To: All Prospective Bidders
Re: Plyler Park Renovation
Date: January 2018

We would like to take this opportunity to inform you that the Plyler Park Renovation Invitation for Bid (IFB #18-B0073) has been cancelled in its entirety. We would also like to inform you that a new Invitation for Bid (IFB #18-B0094) for the Plyler Park Renovation project has been created. The Plyler Park Renovation Drawings, Addenda 1 thru 8 and revised Specifications associated with IFB #18-B0073, as well as this Cover Sheet outlining applicable information, shall hereby be incorporated and be made part of this current Invitation for Bid (IFB #18-B0094).

Plyler Park Renovation

Questions and Answers
Pre-Bid Conference for Plyer Park Renovation
December 8, 2017

Consulting Engineers, Surveyors, Planners,
Landscape Architects & Environmentalists
1298 Professional Dr., Myrtle Beach, SC 29577
Phone: (843) 692-3200 Fax: (843) 692-3210

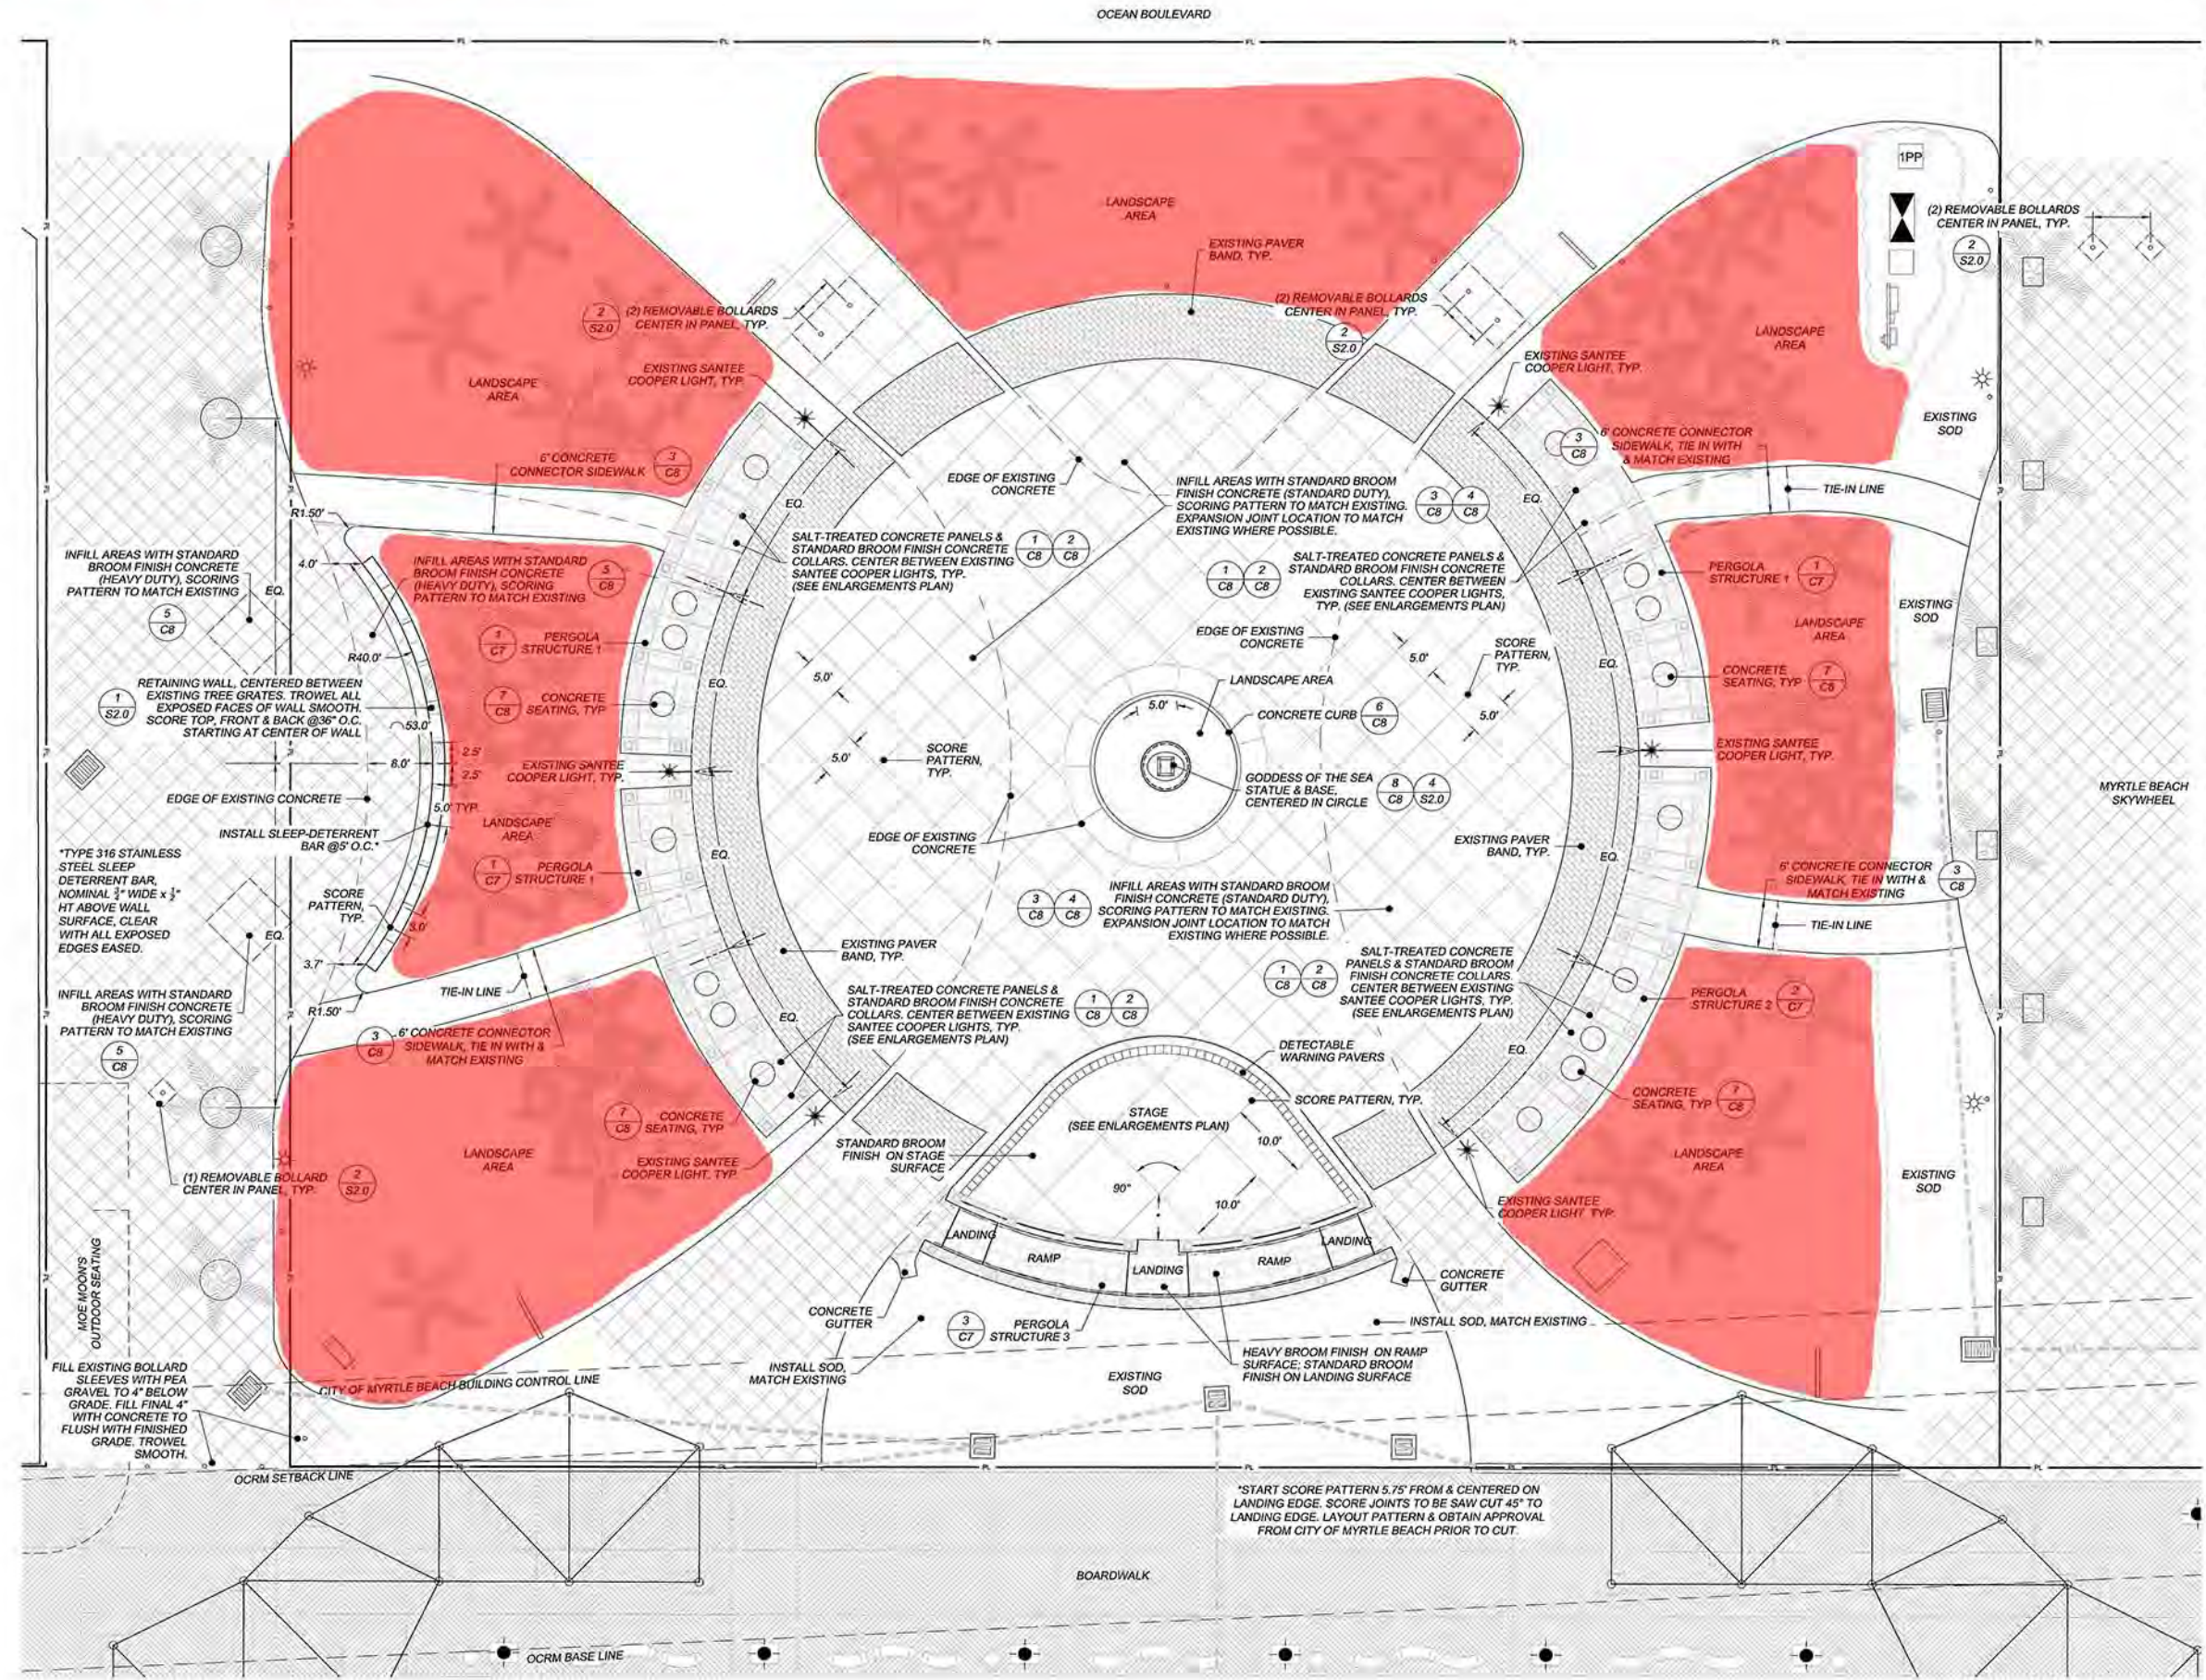
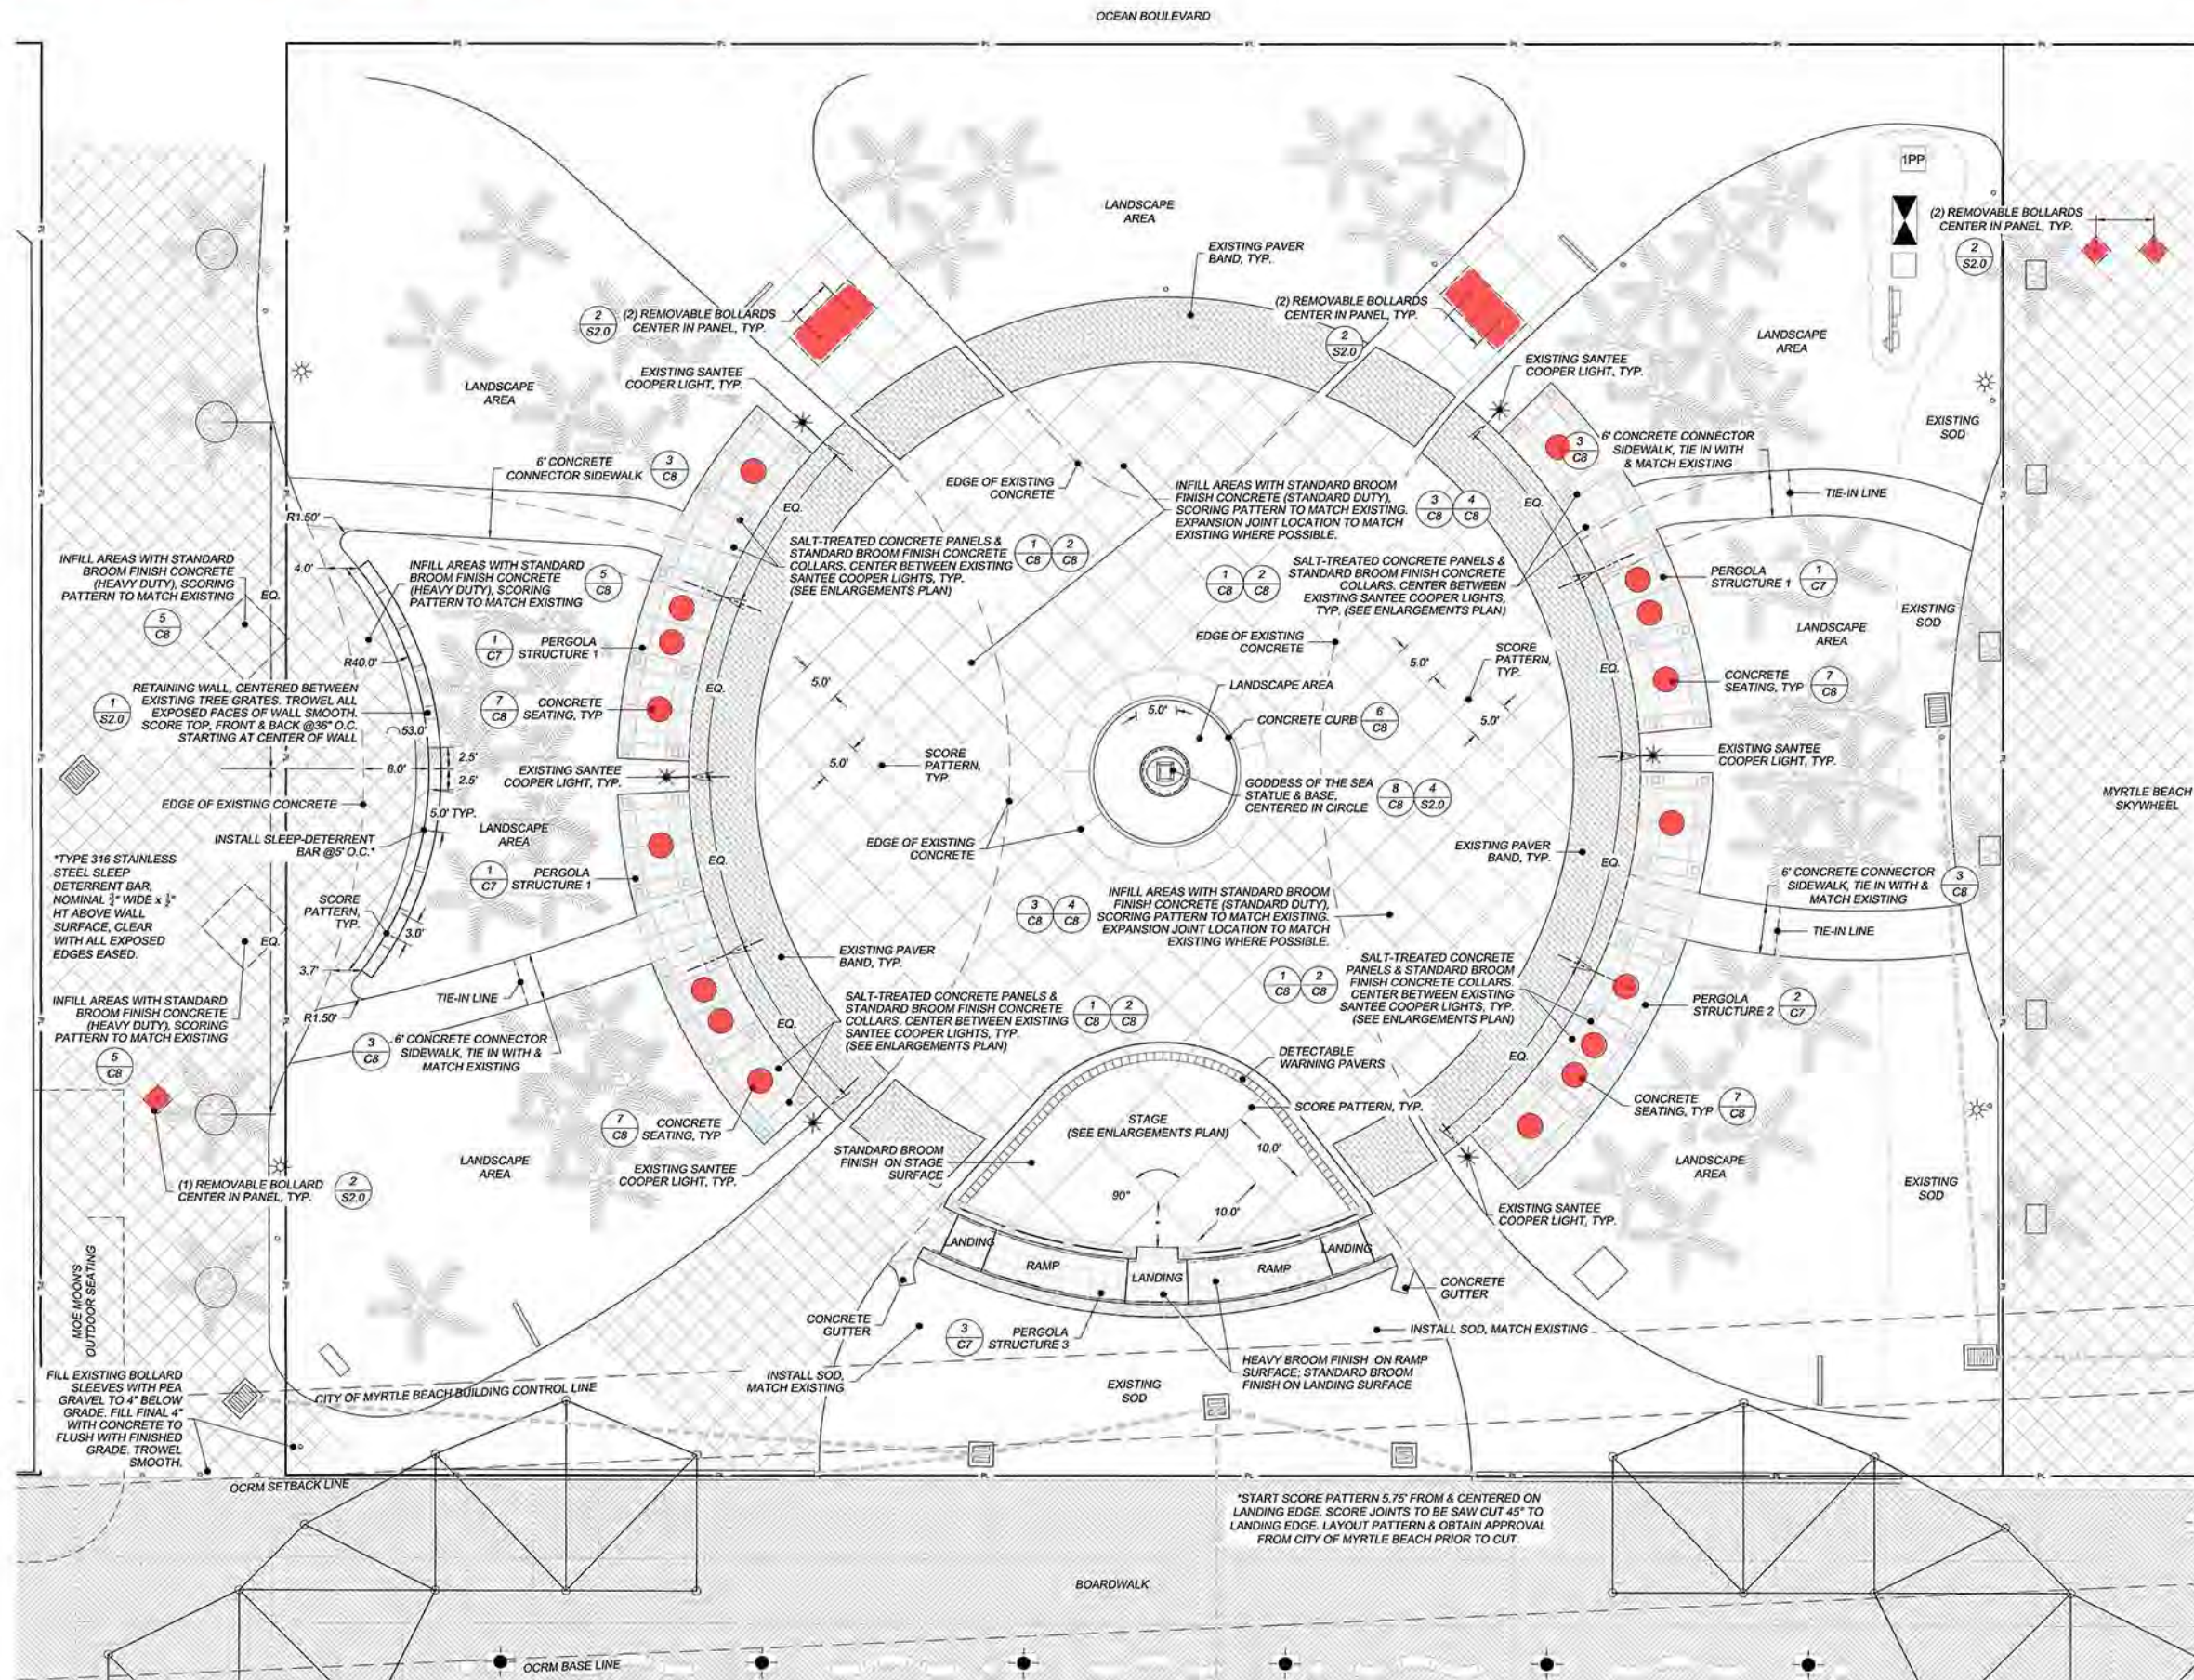
5. Q: Landscaping - No plans to tell us what to plant.

Please see attached for L1, L2 and the revised irrigation sheets. Also, see revised plan and notes on E1.0 and attachment for fixture specification. Fixture shall be 18W 4000K color temperature with black finish. Contractor shall replace existing Drawing and Addendum #3 clarification item with the revised Drawing.

A: No plant material, with the exception of a small amount of sod behind the stage, is included in this contract. Please refer to C4 for direction in the landscape areas.
